Enclosed please find the additional information you requested in your letter of December 17, 1987, relating to the request by NBS for an amendment to the NBSR Technical Specifications.

RESPONSE TO NUCLEAR REGULATORY COMMISSION QUESTIONS OF DECEMBER 17, 1987

Figure 1

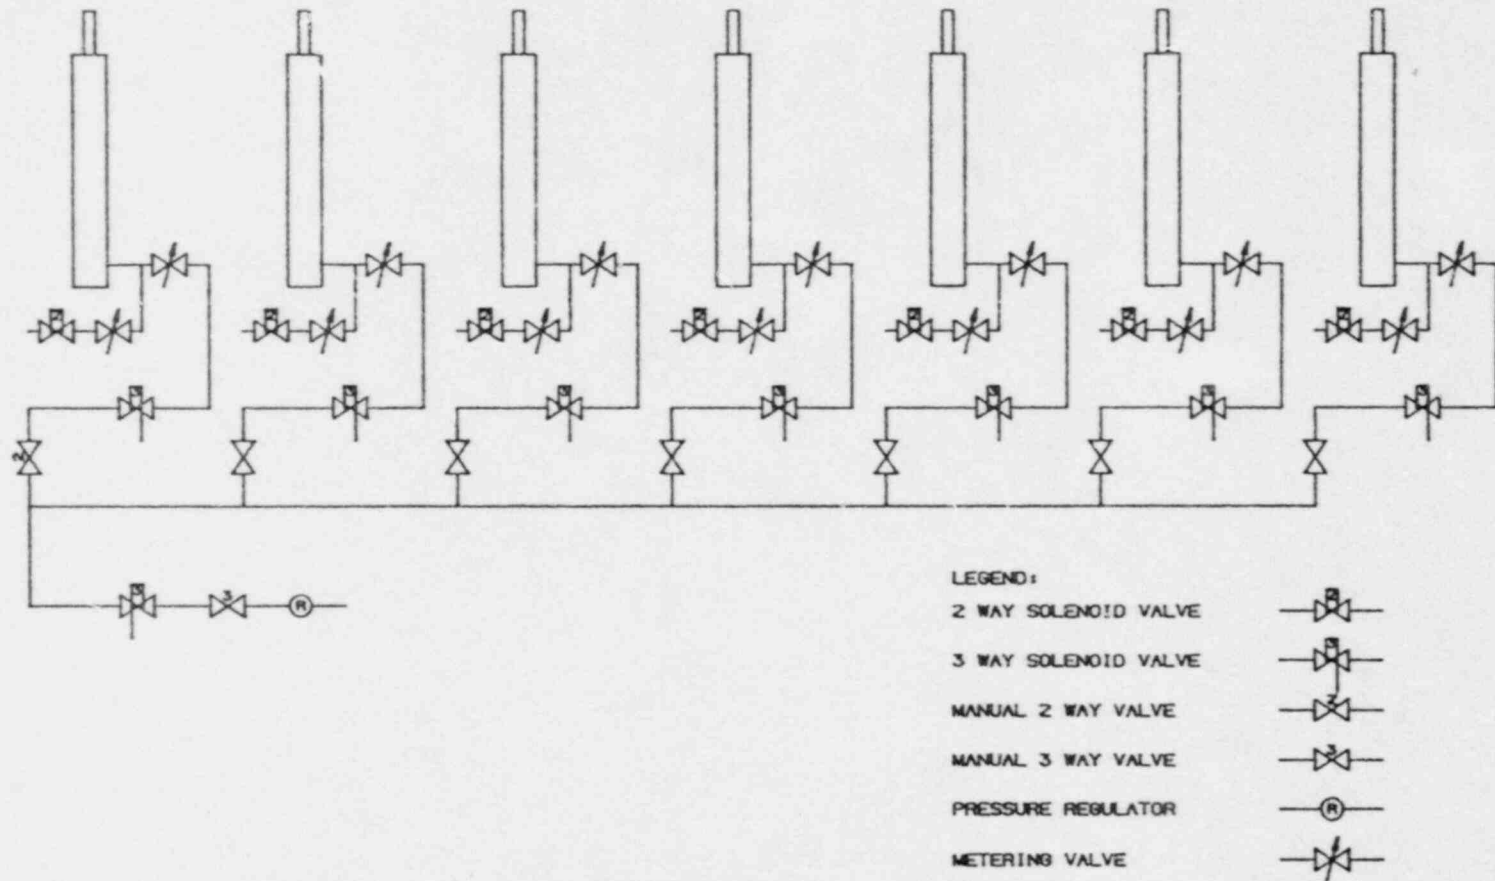
2. Requested information. With regard to the confinement building control system, as related to the isolation valves, provide the following:
  - a. Show how all controls will be redundant up to the motor starters or final solenoid valve for each isolation valve.
  - b. How will the isolation valves be actuated by sensing instruments (radiation and pressure detectors) and master relays and how these instruments and relays will be duplicate and independent.
  - c. How sufficient indication and control will be available in the emergency control center to indicate the status of each vital component and to allow manual control should its automatic control malfunction. This manual backup shall be in addition to the redundant automatic controls.

- a. The isolation valves are opened pneumatically against gravity as discussed in the earlier NBS submittal. The isolation valves are closed by opening solenoid valves that vent the pneumatic cylinders (See Fig. 1). Each cylinder has two solenoid valves either of which will vent the cylinder thereby providing redundancy. The signals to open the solenoid valves to close the isolation valves in the case of a major scram will be the same as those currently used (and previously reviewed by NRC) to initiate the other building closure mechanisms.
